Application no: H15-0941-09

Description: Details of bricks and panel showing mortar mix, extent of brickwork repairs and support structure to gable wall and alternative constructional details for cast iron sash weights and traditional cill (Conditions 2, 3, 4 and 6 of H15-0938-08)

Amendment: Revised sash window detail, gable support and floor joist calculations (dwg. no.W1C)

ACKNOWLEDGEMENT OF AMENDMENT

SECTION A-A

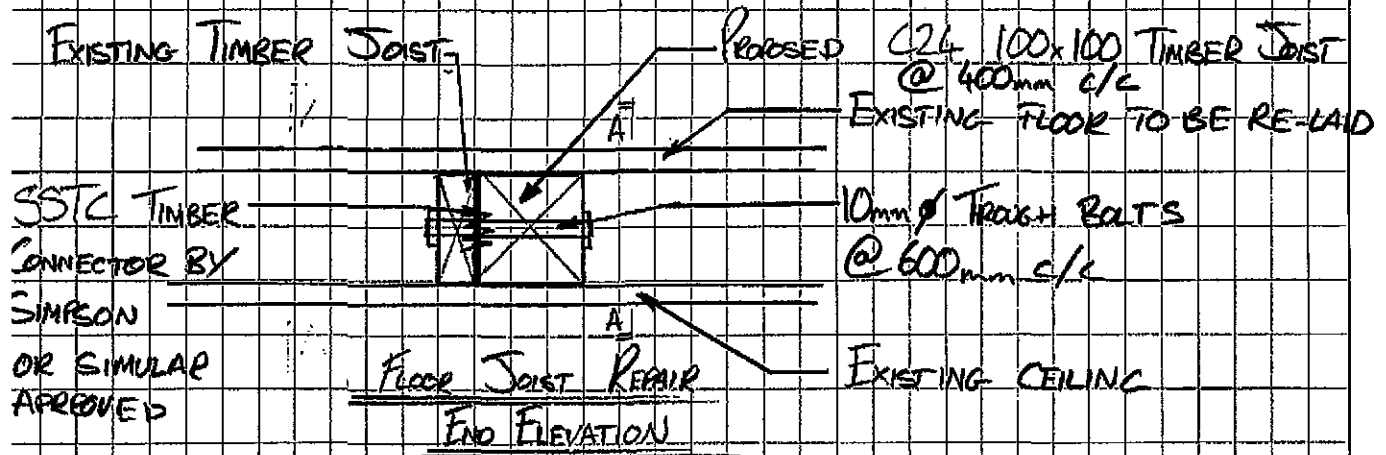
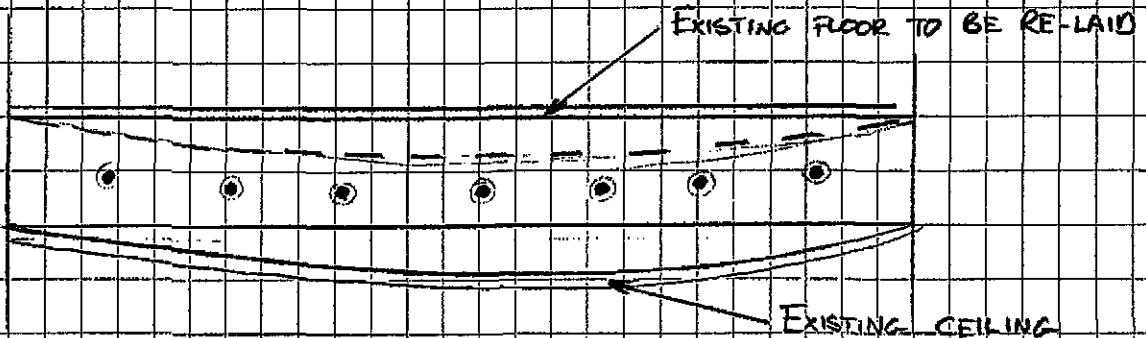
- The S.E.'s proposal to strengthen the first floor structure may be acceptable, but from the information provided it appears that the floor level of the first floor room will be raised to take account of the greater depth of the new joists. What impact will this have in terms of the floor structures relationship to the existing staircase, skirtings, cupboard and bedroom door?

The engineer has revised the strengthening to the floor joists. The joist depth has been reduced from 175mm to 100mm to match the depth of the existing joists, this means that the floor joist strengthening will have no impact on the relationship between the floor and staircase, skirtings, cupboards and bedroom door.

Do NOT SCALE
SKI REV A JUN 10

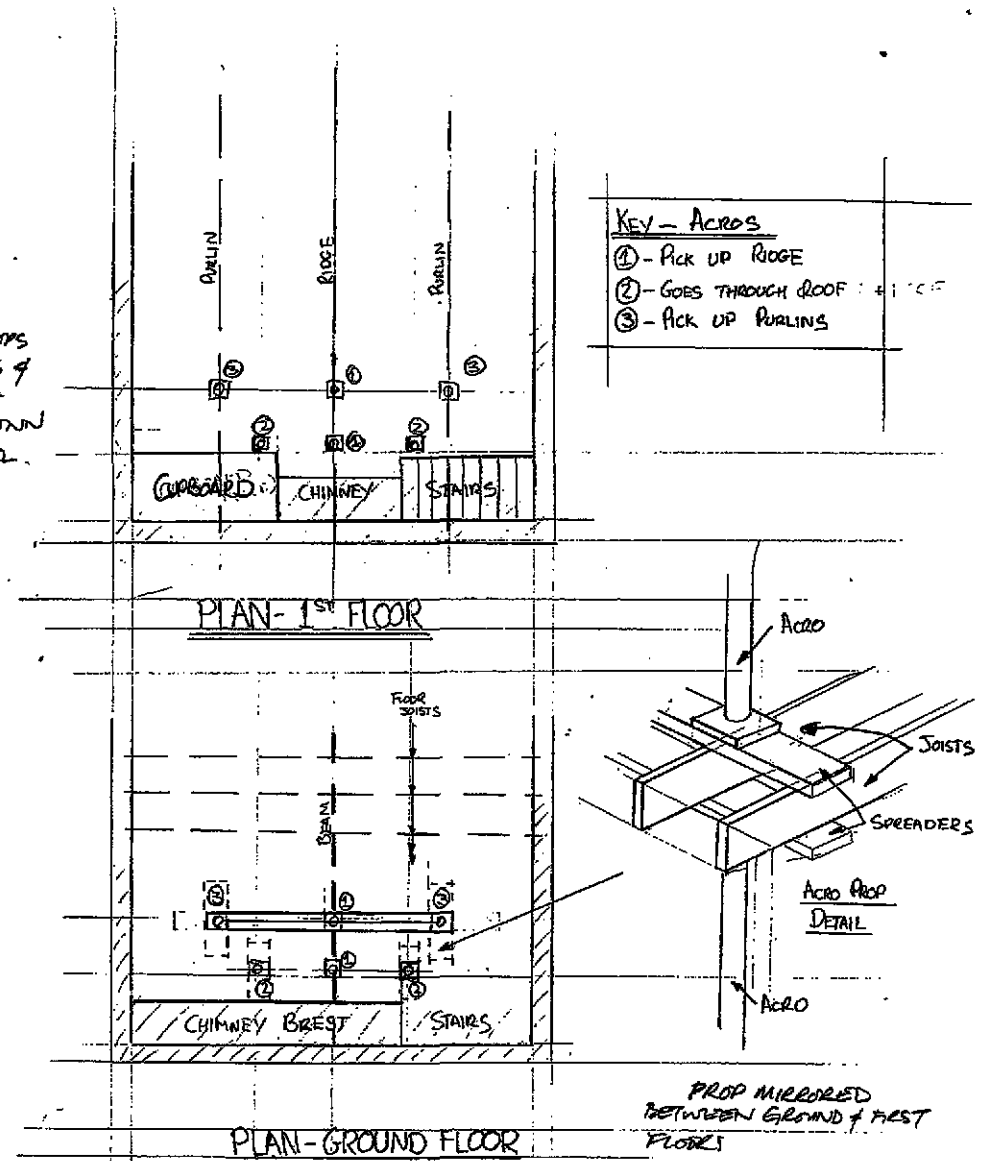
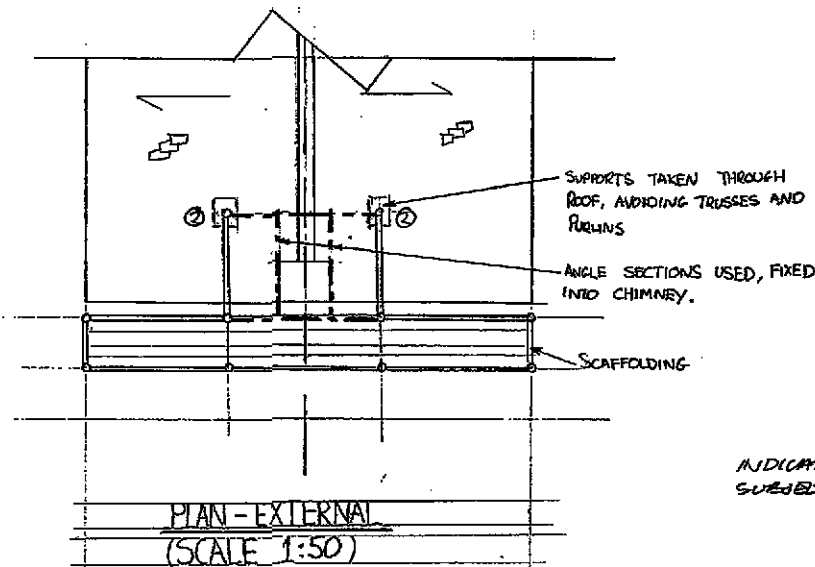
- Dwg SK1 also states that the existing cupboard will be moved to allow for the introduction of the support scaffold, whereas the approved drawing states that the cupboard will be retained. How will this be undertaken, and what will the effect on the historic joinery be?

The note stating that the existing cupboard is to be removed to allow for the introduction of the support scaffolding on the structural engineer's detail SK1 has been removed, the support scaffolding is also shown as being clear of the cupboard.

SK2

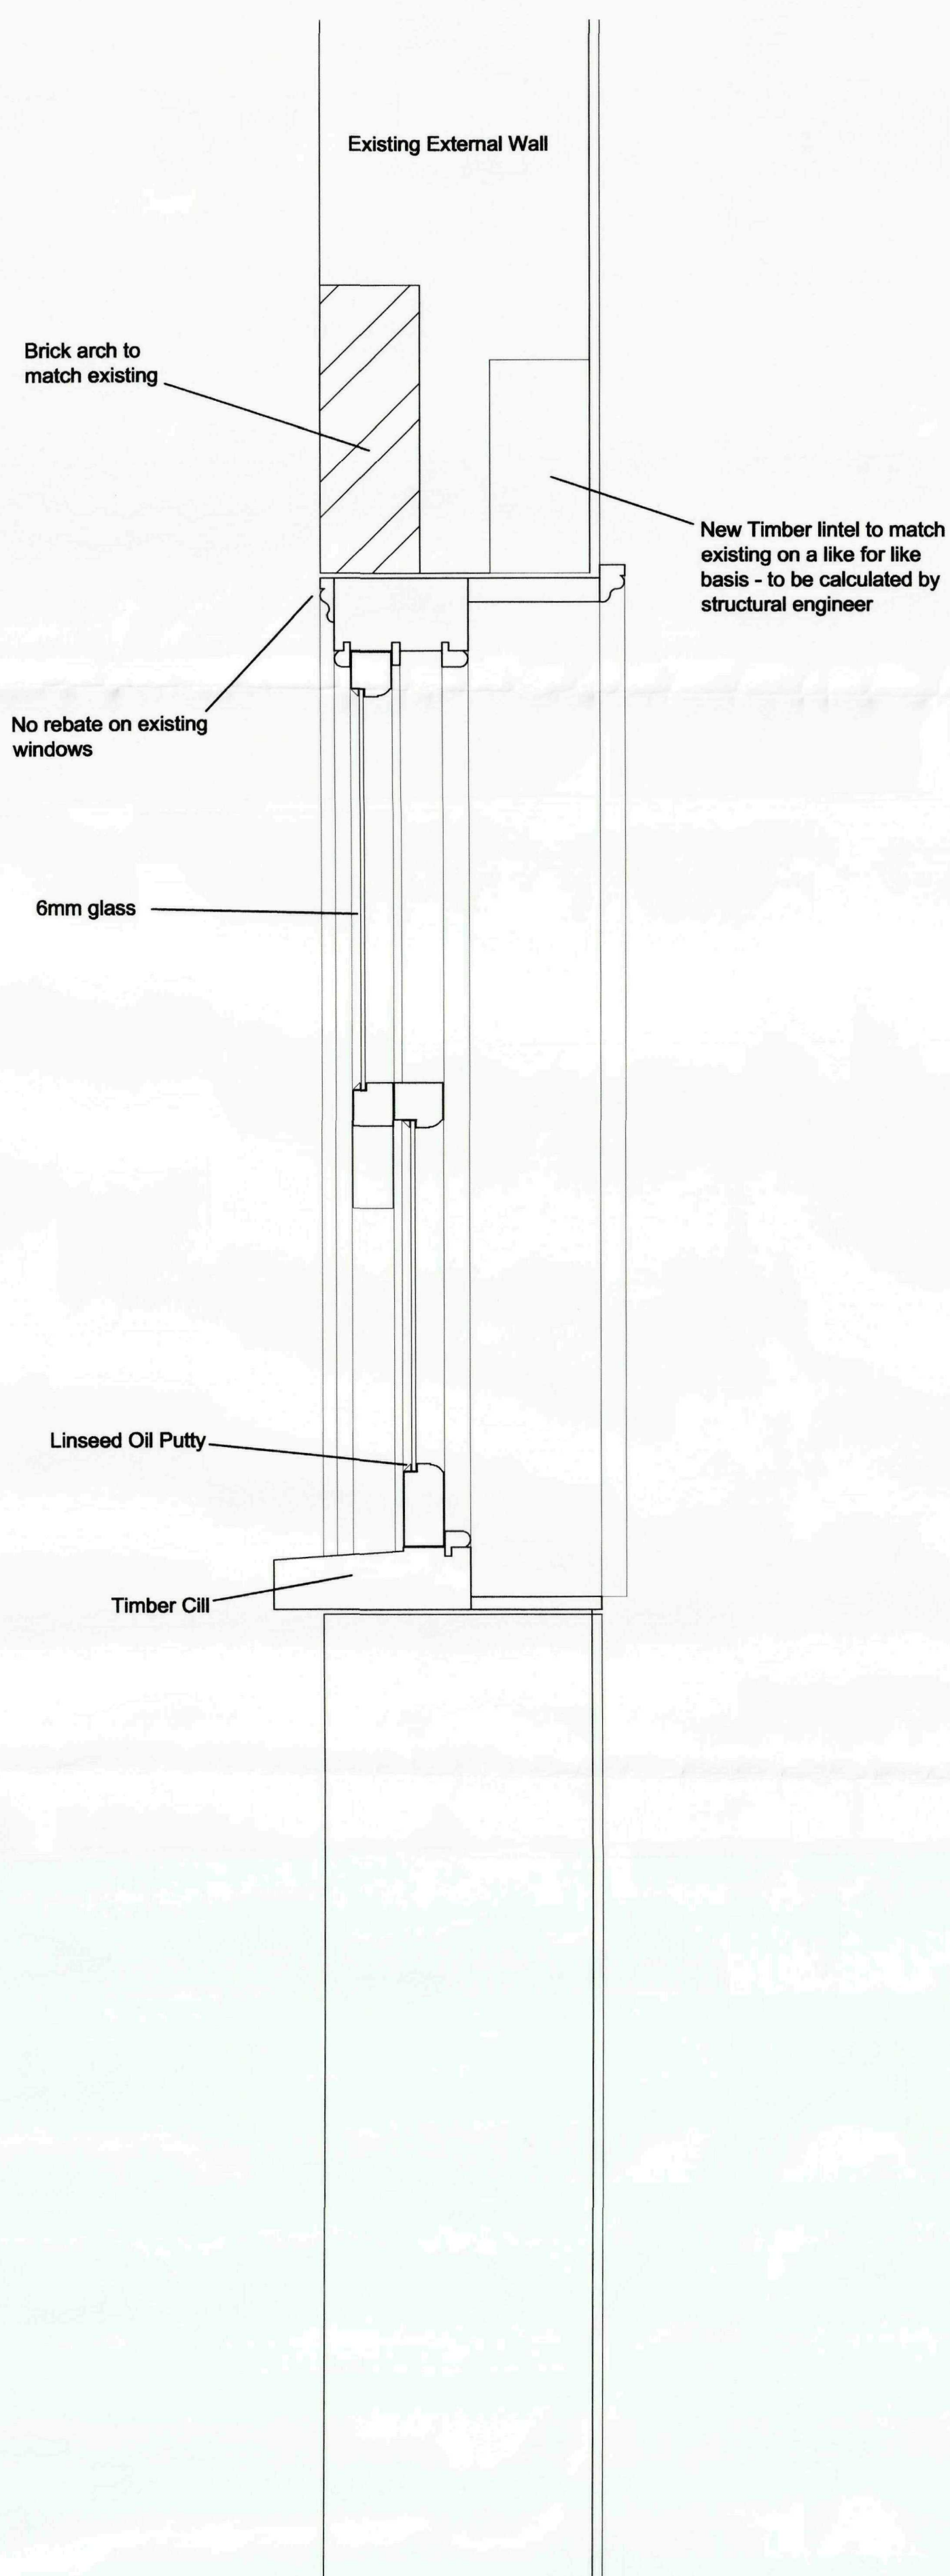
- Dwg SK2 contained within the structural survey is annotated to suggest that the existing chimney stack may be demolished and rebuilt. Clearly this goes beyond the scope of the consent, and without an overriding justification this will be resisted. Separate consent would be required in any event.

The note suggesting that the existing chimney stack maybe demolished and removed on the structural engineer's detail SK2 has been removed.

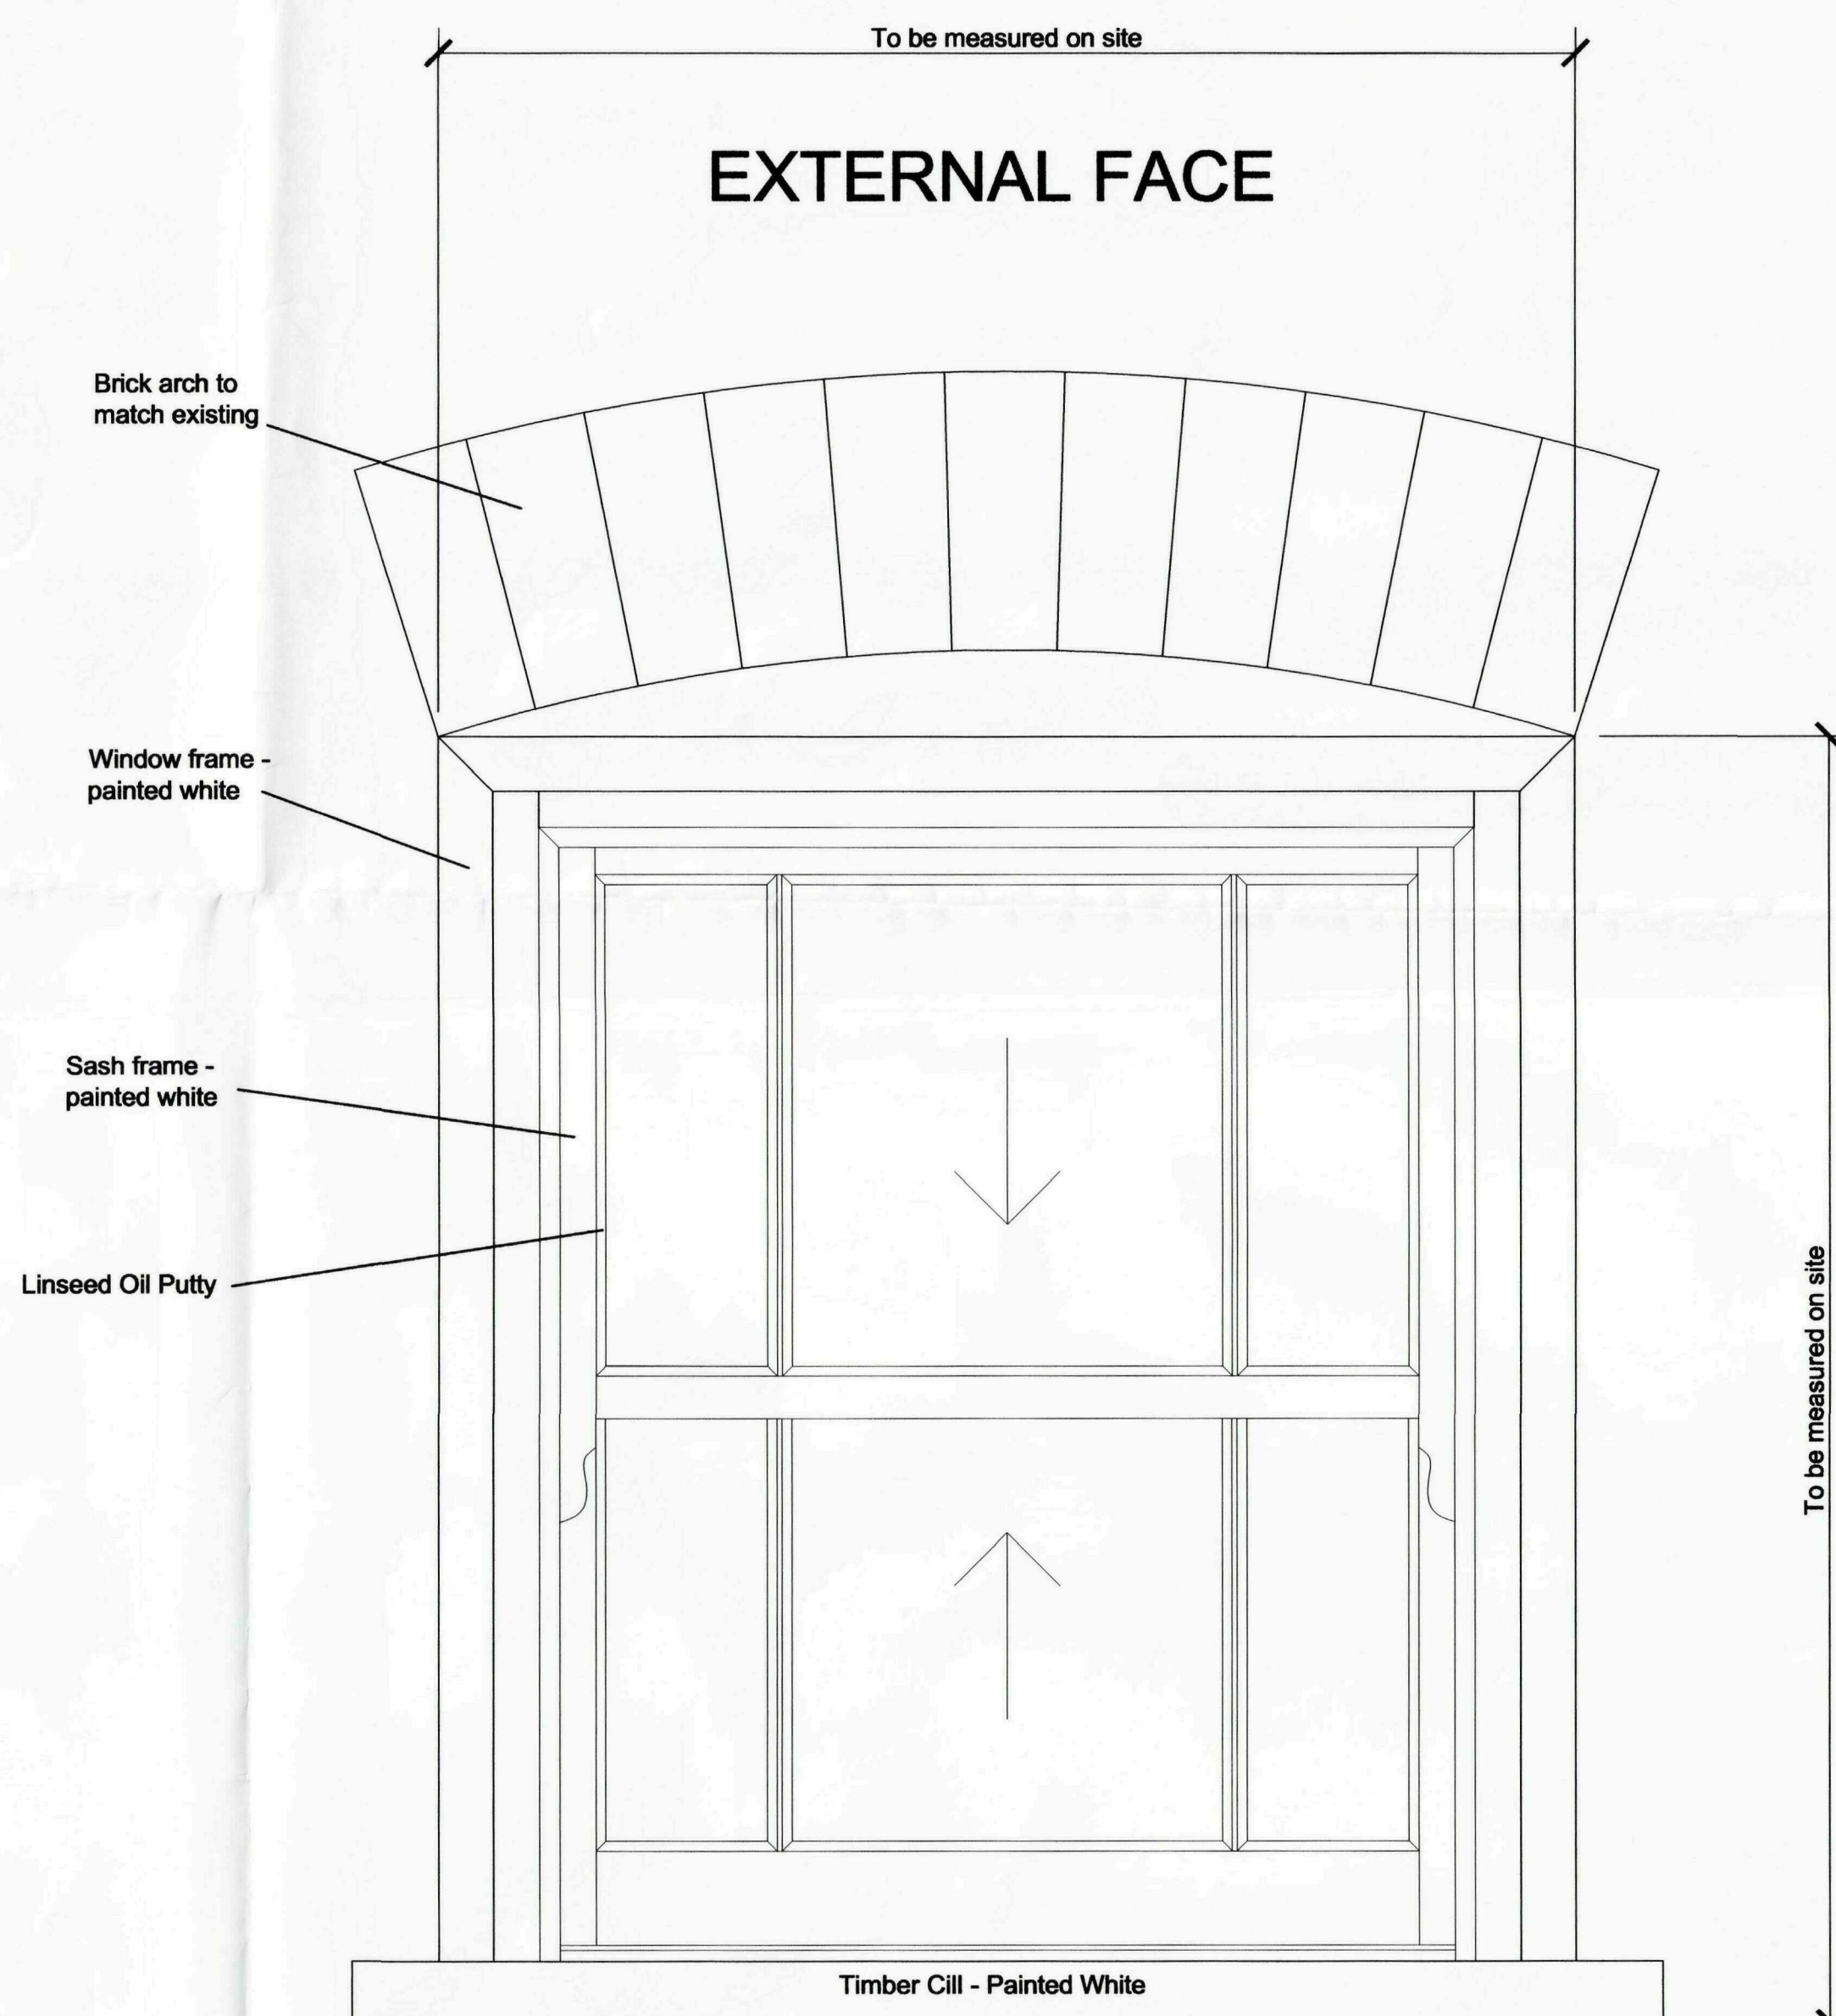
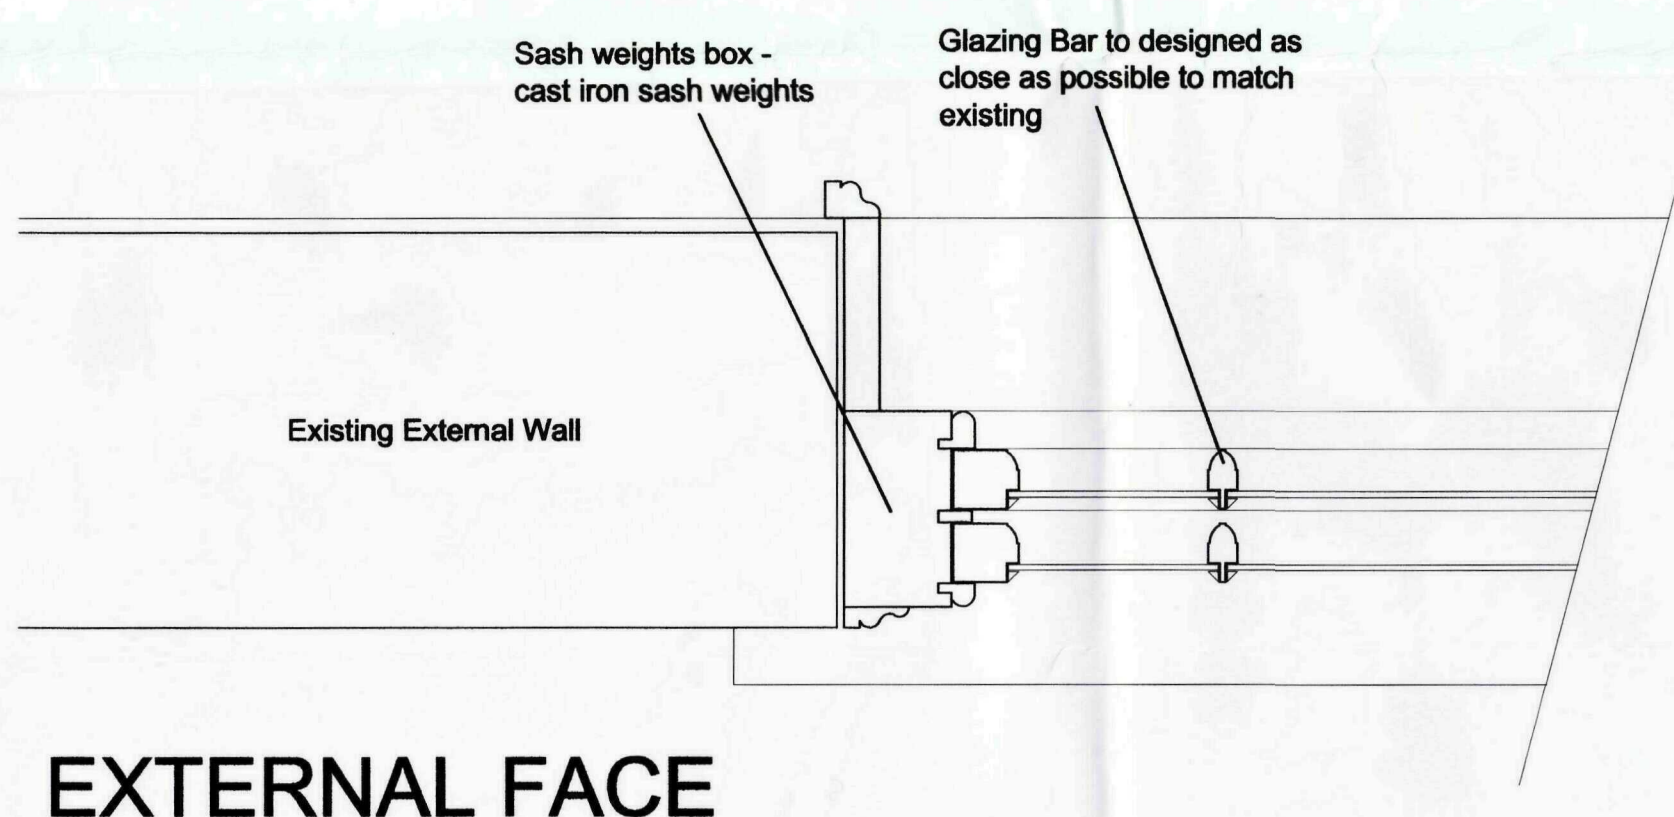
- I'm slightly concerned by the woolly detail on the window drawing- the external masonry is being rebuilt to match the existing opening, and it is the existing opening rather than the rebuilt section of wall that is the driver here.

The note on drawing 07099/W1C has been revised to read existing window dimensions are to be checked on site by the joinery manufacturer and matched; the note also states window ironmongery to be installed.

NOTE: These details indicate sizes and shapes of joinery for planning purposes. Existing Window Dimensions are to be checked on site by the joinery manufacturer and matched, the window is to be fitted with 1 No PB sash fastener, 2 No PB sash lift and 2 No brass ventilating sash window lock.

Rev C January 2010 Existing dimensions to be matched, ironmongery added
Rev B November 2009 Weighted sash rather than spiral, cill detail revised
Rev A November 2008 Internal timber lintel
